## 7.0 Instrumentation and Control Systems

### 7.1 Introduction

The information in this section of the reference ABWR DCD, including all subsections and tables, and figures, is incorporated by reference with the following departures and supplements.

Figure 7.1-1 ~~SSLC Self-Test System~~ Diagnosis

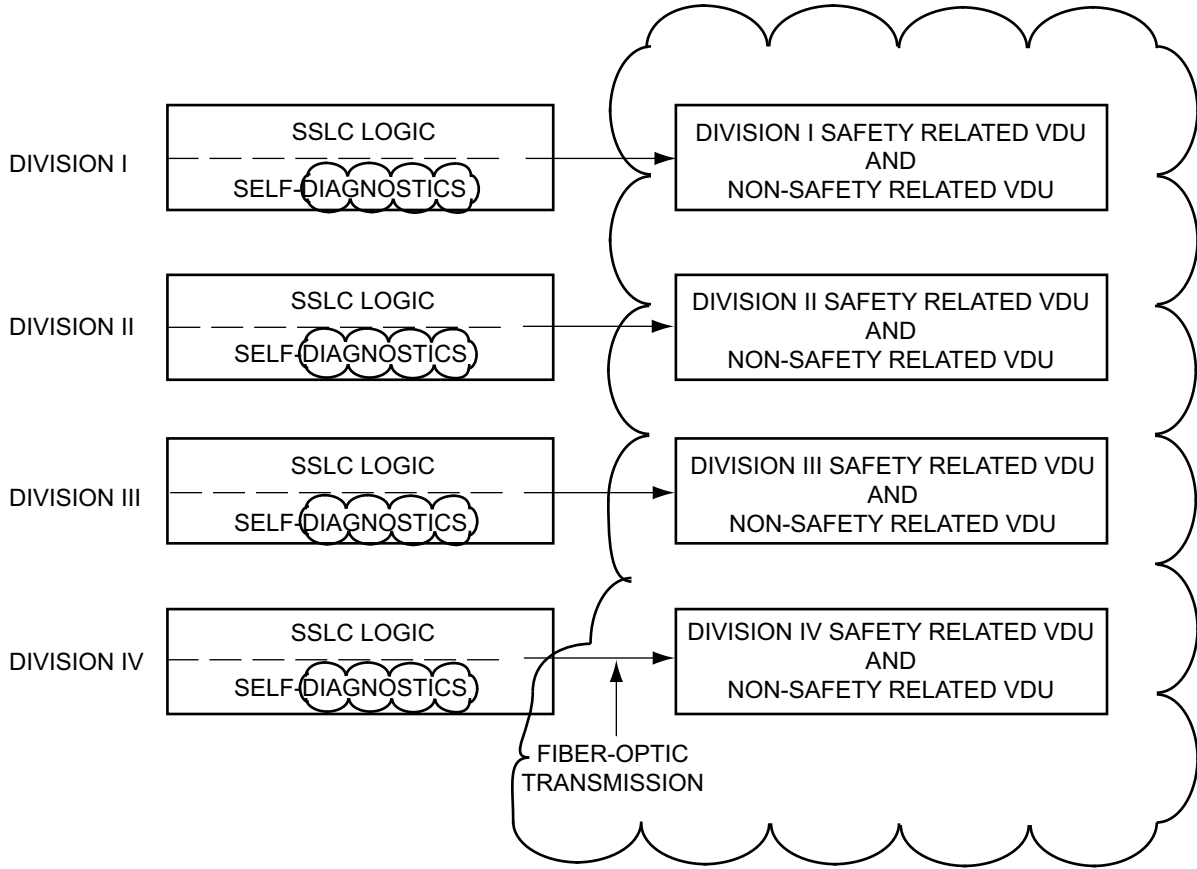
STD DEP T1 3.4-1 (Figure 7.1-1, 7.1-2)

STD DEP T1 3.4-1

*The RPS RTIS and ESFELCS Systems can be tested during reactor operation ~~by six separate tests.~~ The first five tests are primarily manual tests and, although each individually is a partial test, combined with the sixth test they constitute a complete system test. The sixth test is ~~the self~~ test of the safety system logic and control which ~~automatically~~ tests the complete system excluding sensors and actuators.*

The primary purpose of the self-test diagnostic function is to improve the availability of the SSLC by optimizing the time to detect and determine the location of a failure in the functional system. It is not intended that the self-test diagnostic function eliminate the need for the other five manual tests. However, most faults are detected more quickly than with manual testing alone.

The self-diagnostic function does not degrade system reliability. Indications of test results (pass, fail) is provided.

Actuation of the trip function is not performed during this test. The self-test diagnostic function is capable of detecting and logging intermittent failures without stopping system operation. Normal surveillance by plant personnel will identify these failures, via a diagnostic display, for preventive maintenance.

Self-test diagnostic failures (except intermittent failures) are annunciated to the operator at the main control room console and logged by the process plant computer functions (PCF). Faults are identified to the replacement board or module level and positively are generally indicated at the failed unit.

~~Self test~~ Test failures are displayed on a front panel readout device or other diagnostic unit.

Figure 7.1-2 Assignment of Interfacing Safety System Logic to SSLC Controllers

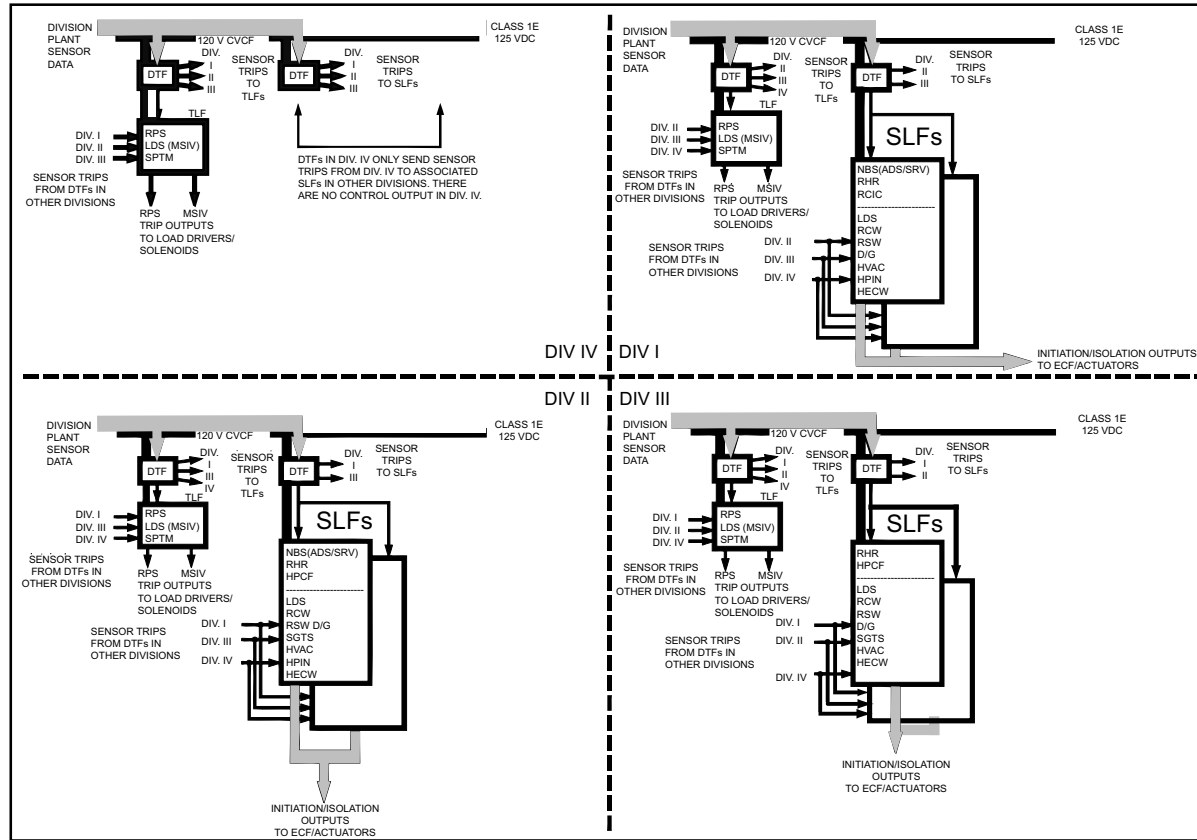
Sensor signals are hardwired to the RTIS. These sensors are divisionally separated.

Divisional separation is applied to the Essential Communication Functions (ECFs) of ELCS, which provides communication for the sensor input to the logic units and for the logic output to the system actuators (actuated devices such as pump motors and motor-operated valves).

~~Divisional separation is also applied to the essential multiplexing system (EMS), which provides data highways for the sensor input to the logic units and for the logic output to the system actuators (actuated devices such as pump motors and motor operated valves). Systems which utilize the SSLC are include: (1) Reactor Protection (trip) System; (2) High Pressure Core Flooder System; (3) Residual Heat Removal System; (4) Automatic Depressurization System; (5) Leak Detection and Isolation System; (6) Suppression Pool Temperature Monitoring System; and (7) Reactor Core Isolation Cooling System. The equipment arrangement for these systems and other supporting systems is shown in Figure 7.1-2.~~
